City of Palo Alto

City Council Staff Report

Summary Title: Resolution Correcting Wood Pole Wireless Standards

Title: Adoption of a Resolution Amending Objective Standards for Wireless Communications Facilities in the Public Rights of Way (Continued From June 3, 2019) to Delete Inadvertently Added Language, Clarify Existing Standards, and Adopt an Interim Setback from Schools

FIGURE 1

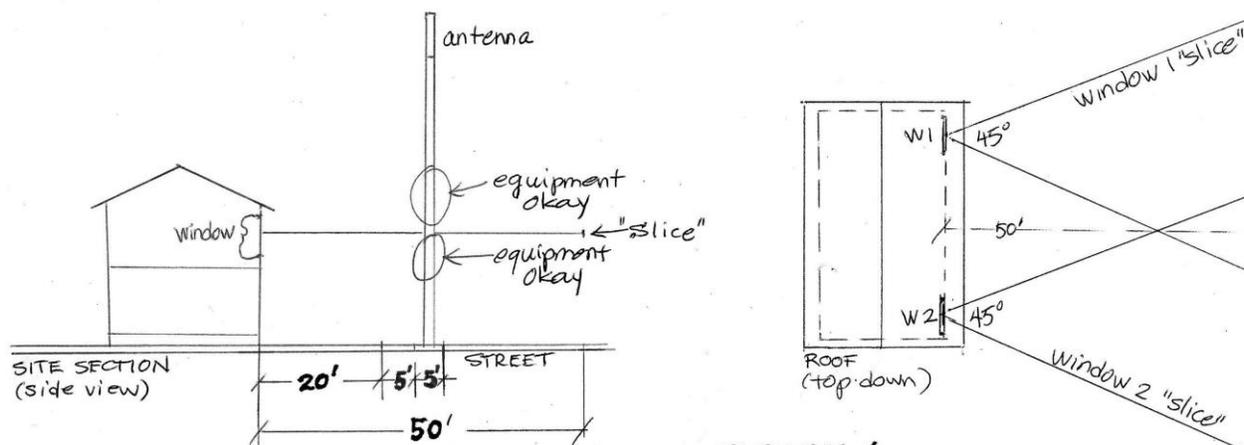
The adopted standards for the placement of small cell nodes on Wood Utility Poles inadvertently included draft text (Attachment A, Exhibit 2, page 2, item number 22) that staff did not intend as a final standard. This text represents an initial concept to regulate impacts related to second-story windows that staff was unable to fully develop prior to the Council's April 15 meeting. This error was only present in the standards for Wood Utility Poles; it was not included in the standards for Streetlight Poles.

The existing language is poorly drafted:

“22) WCF equipment and antennas shall be located on poles such that they do not fall within the horizontal plane defined by a 45 degree angle extending 50 feet from the center point of upper story windows, doors, balconies, and other openings.”

The most straightforward interpretation of the standard would result in little practical impact. The plain text of the restriction prohibits equipment only within a two-dimensional horizontal area, or “pizza slice”, defined by the center point of upper story windows, balconies or doors and two lines, separated by 45 degrees, extending from that center point to a distance of 50 feet (see Fig. 1 below). An applicant could easily comply with this standard by slightly shifting equipment placement, and it therefore represents a limited restriction on placement of WCFs. Additionally, the restriction applies only for upper story locations and offers no similar limitation for single-story structures.

After careful review, staff determined that alternative interpretations restricting WCF placement within a three-dimensional space are unsupported by the language as currently drafted. Staff are not prepared at this time to propose alternative language that would create a more effective restriction, as additional analysis is required to understand the practical and policy impacts of such a standard. For example, it is unclear whether it is desirable to prioritize multi-story structures over single-story structures. In addition, City policies and regulations typically regulate from the perspective of streetscape and street design (e.g. Comprehensive Plan Goal L-9 and Policy L-9.10), rather than with respect to features of private property such as windows or door openings that may change over time. Staff are in the process of conducting the additional analysis necessary to develop additional standards and hope to return with more thoroughly-considered proposals in advance of the 1-year timeline directed by the Council on April 15, 2019.

The attached resolution shows in redline the proposed deletion of the erroneously added language with respect to Wood Utility Poles, the added clarifications that WCFs may not be attached to poles in locations other than the public right of way (e.g. along private rear or side lot lines), and the new interim standards governing WCF distances from public schools. Staff will continue to develop the City's objective aesthetic standards for WCFs consistent with the Council's direction on April 15, 2019.
